September 25, 2025

This addendum forms a part of the contract documents and modifies the original bid documents for the project.

AD3.16 C-301 PLAN AND PROFILE OPHIR CREEK ROAD

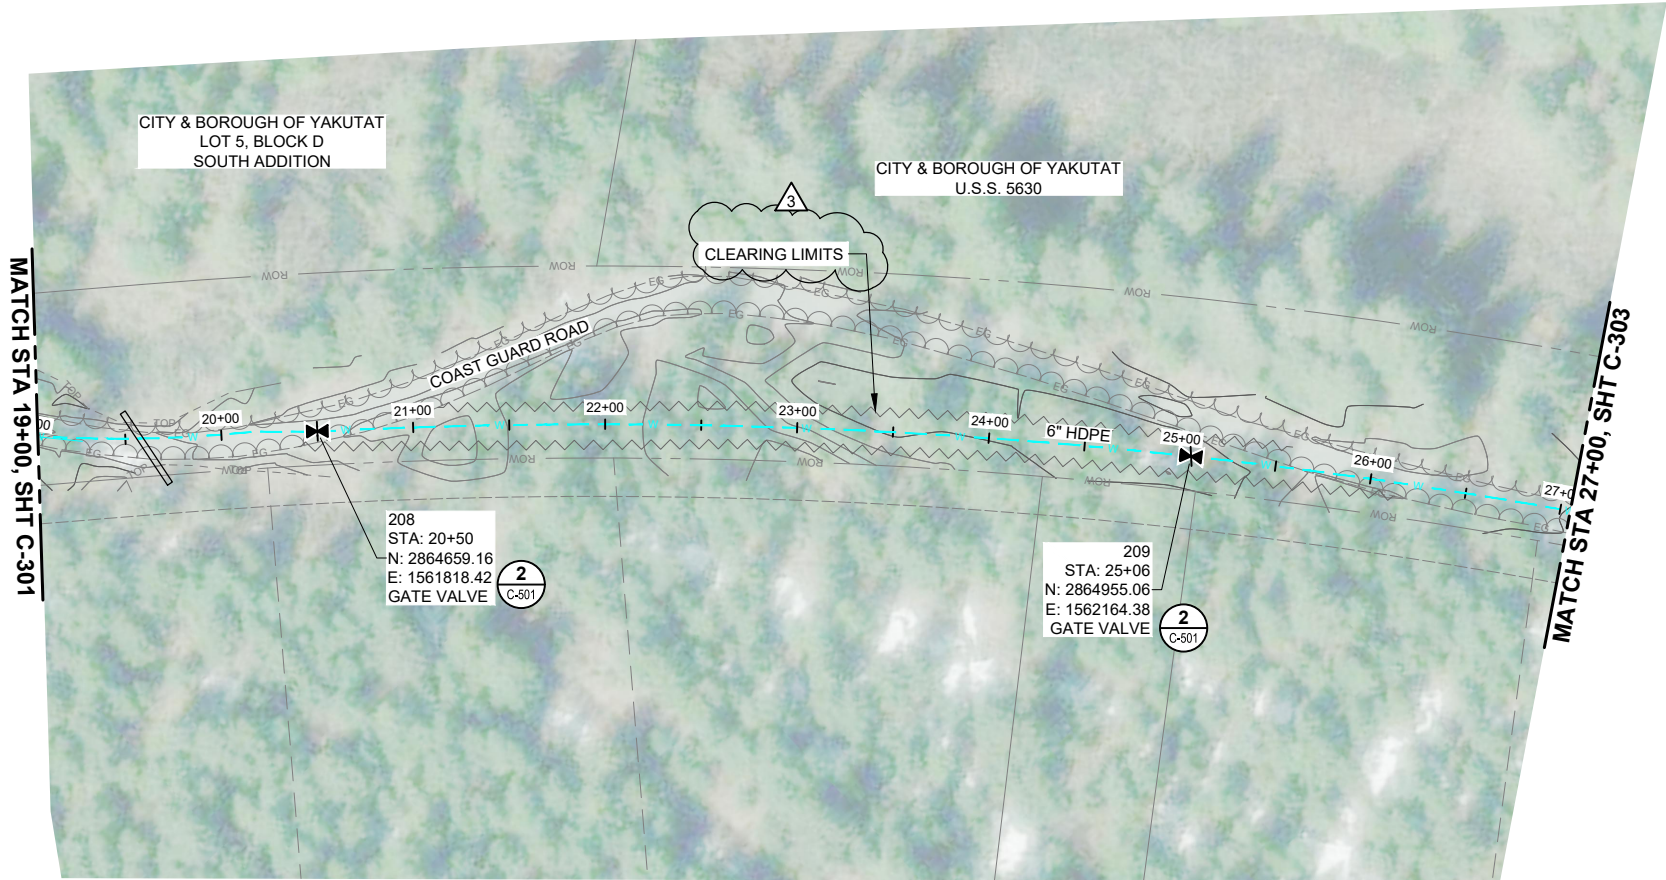
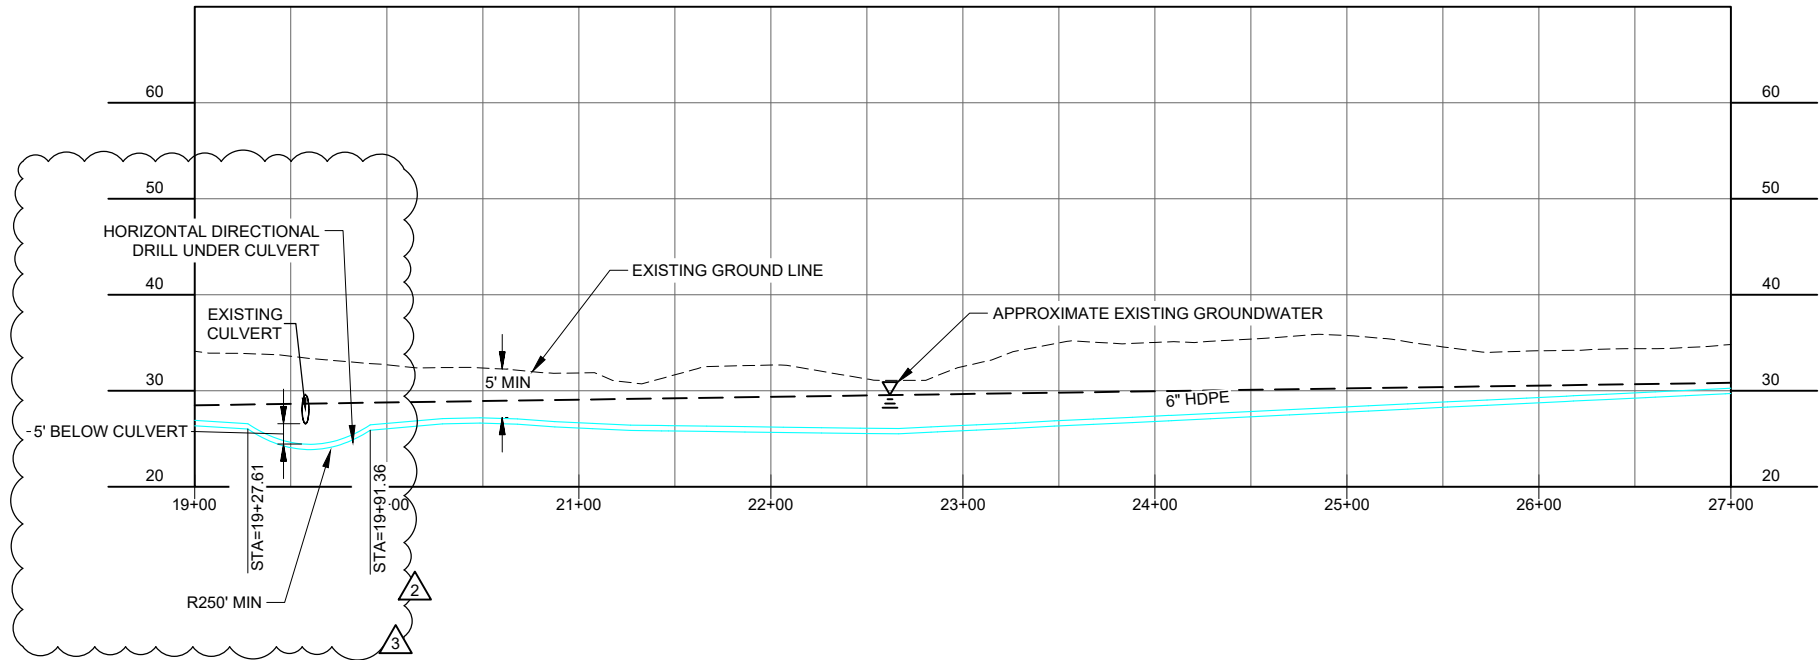
- Added Clearing Limits
-

6. **QUESTION:** Dwgs. C-301 to C-303: The designed water line alignment will require significant tree removal and impact countless Critical Root Zones of peripheral trees. Could this alignment get shifted into the existing gravel roadway to avoid disrupting the densely forested areas?

RESPONSE: The alignment of the gravel trail meanders through the ROW and near Ophir Creek outside of the ROW. Please bid the alignment as shown with clearing required. Clearing pay item has been updated from lump sum to be by acre.

SHEET TITLE :
AIRPORT ROAD TYPICAL SECTION

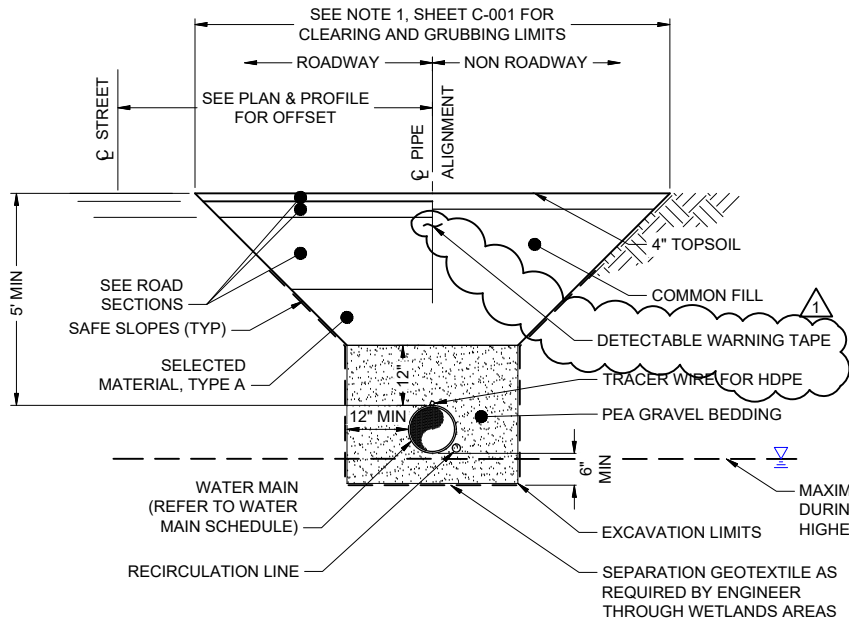
- Revised ditch slope from 4:1 to 2:1 to match existing.

24. **QUESTION:** Dwg. C-401 Typical Roadway Section (Bid Form's "Ditch Realignment" paid per LF): The existing Edge of Pavement elevation is fixed so contractors will not have any adaptability. Given the design requires 24-feet to 'catch' the bottom of the existing roadside ditch edge, plus the "Match Existing Ditch Width", then finally a 2:1 slope to catch the far-side's existing topography, visual observation makes me believe this concept exceeds the existing ROW limits and/or will breach any existing utilities' minimum bury depths. Please extrapolate CAD limits and verify this 'Typical Section' adequately daylight within the ROW without impacting the forecasted Clearing & Grubbing Lump Sum pay item. Also highlight any locations where bidders may anticipate conflicts with existing utility minimum bury depths.

RESPONSE: The typical section has been corrected to indicate the catch slope is 2:1, to match the existing road slope, not 4:1 as previously labeled. The catch, fill and clearing limits have been added to the C sheets.

4 DETAIL: FIRE HYDRANT SECTION

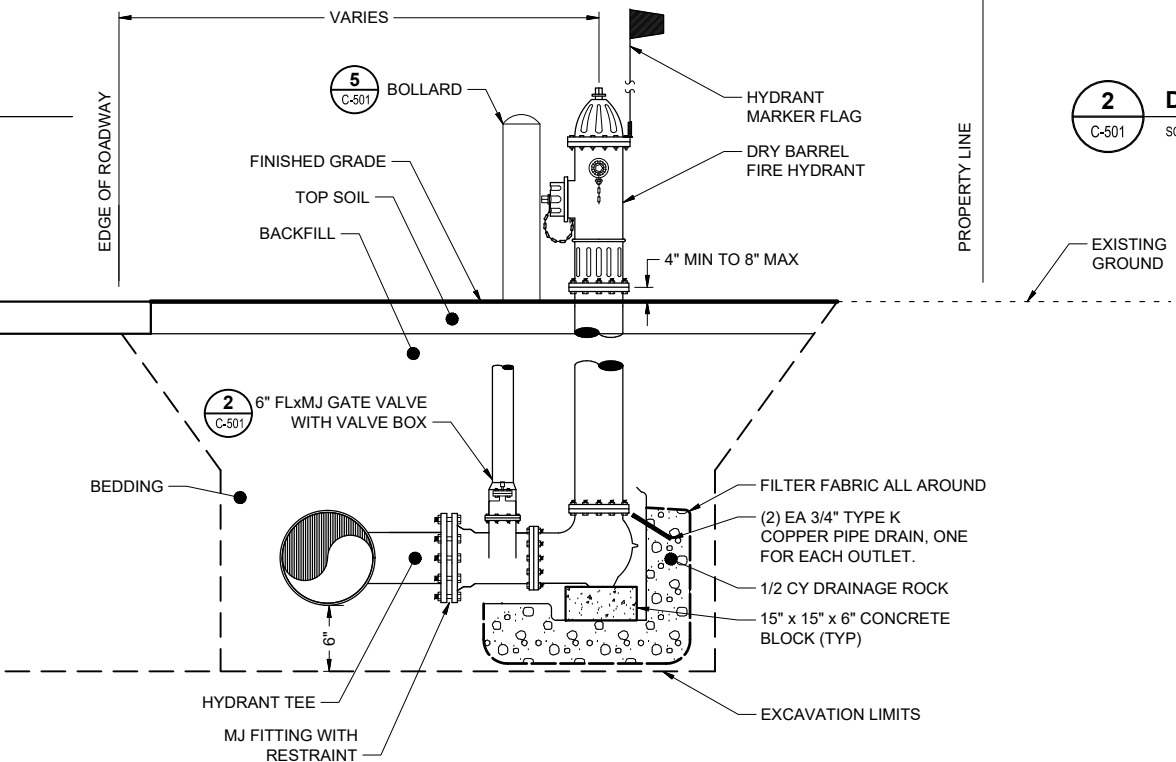
- Updated detail 1/C-507 material and thickness.
- Updated detail 4/C-501. Recirc line has been changed from 3” to 4”
D-002, D-003, D-111, D-112, D-301, D-302, D-511, D-611, D-613

1 **DETAIL: EXTERIOR ABOVE GROUND INSULATED PIPE**
C-507 SCALE: N.T.S

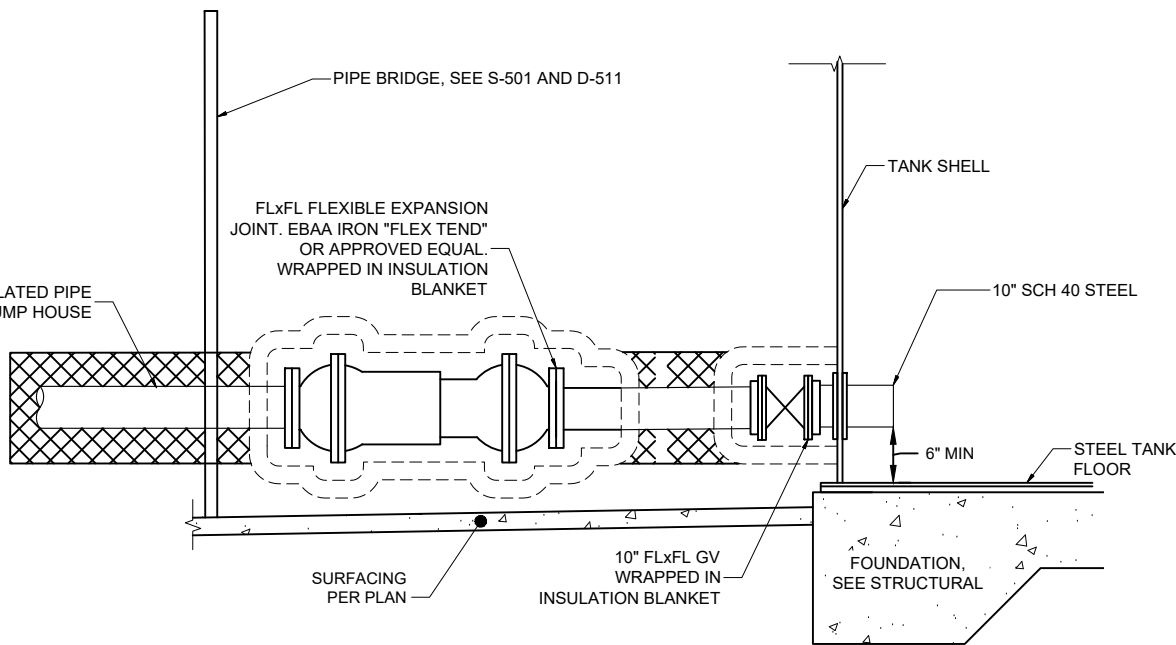
35. QUESTION: D-107 & C-507 Details 2 & 4

RESPONSE: Insulation shall be polyisocyanurate insulation at 2" minimum thickness. Covering shall be an aluminum jacket. Detail 1/C-507 has been modified to match specification 220700 sections 2.05 and 2.06.

D-002

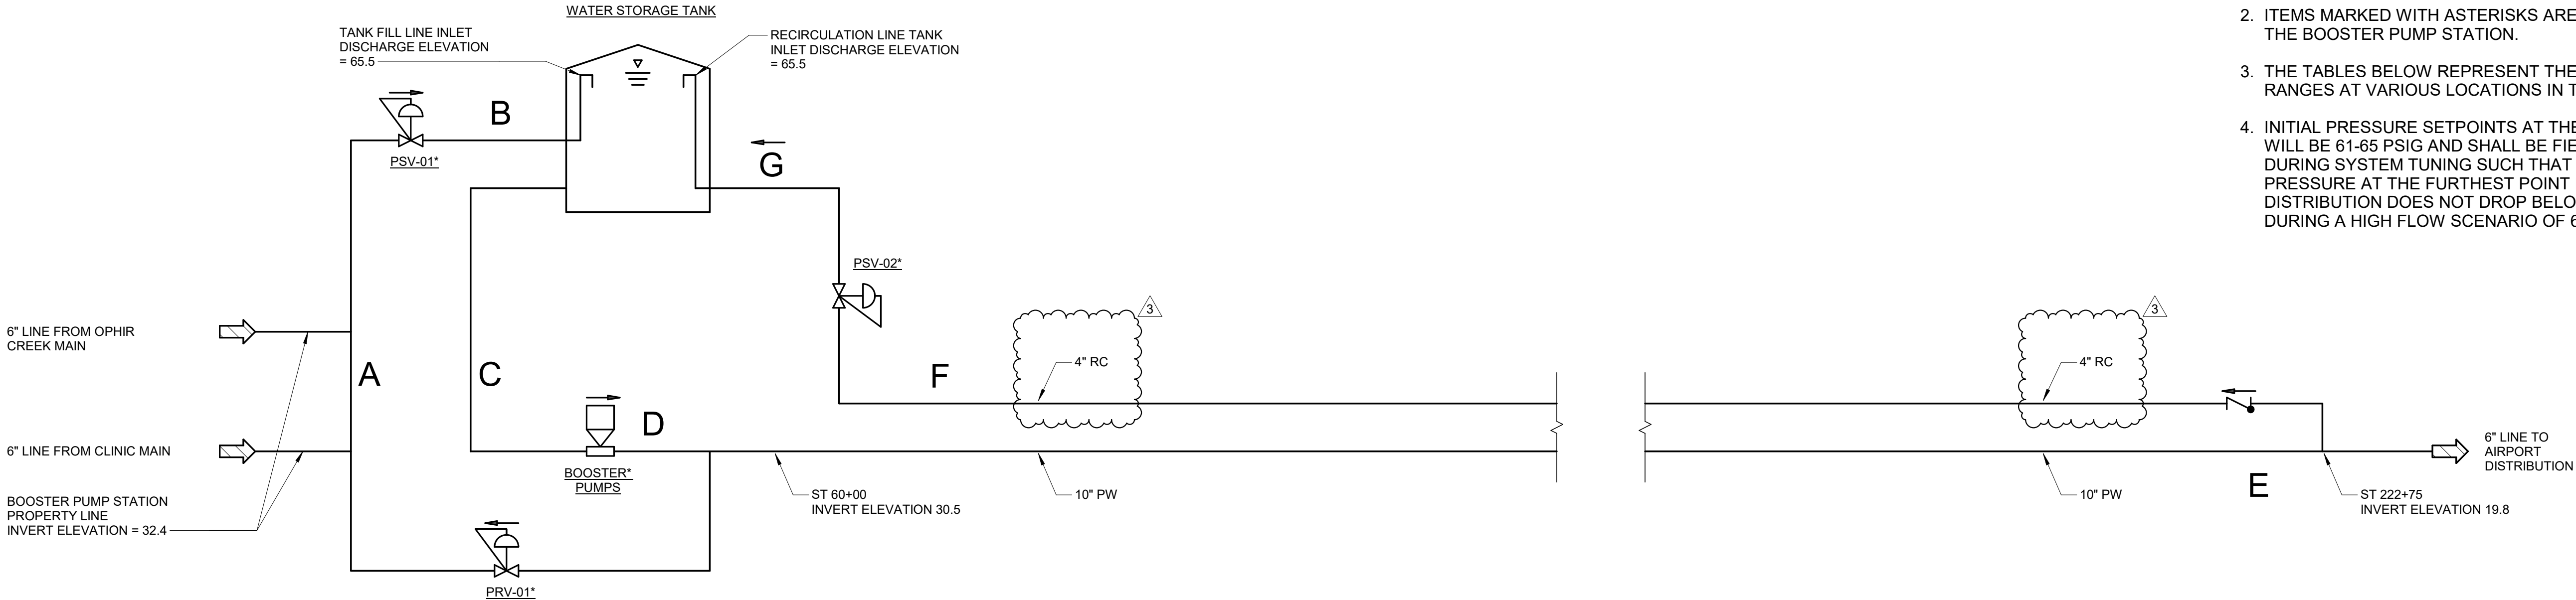
- Updated Actuated Valve Schedule to remove note #7.
- Updated Flow Meter Schedule with basis of design meter part numbers.
- Updated Pipe Schedule. Recirc line has been changed from 3” to 4” and ductile iron pipe pressure class has been updated to C52 or greater.

32. **QUESTION:** On drawing D-002 the Actuated Valve Schedule lists a note #7 that says, "PSV shall include integral pressure relief valve". This note applies to PRV-01 the 4" Pressure Sustaining/Reducing valve. Do you know what the objective of that note is?

41. **QUESTION:** I am needing clarification on the flow meters. The supplier for the meter is telling me they need part numbers that would fit into the table at the end of this M2000 product data sheet before they can provide a quote. Can you provide a part number for the meters? Thank you.

RESPONSE: Drawing D-002 has been revised to remove this note from the Actuated Valve Schedule.

RESPONSE: Drawing D-002 Flow Meter Schedule has been updated to provide full part numbers for the basis of design meter (Badger M2000). A revision has been made in Spec 40 71 13 Magnetic Flow Meter to the calibration requirements.
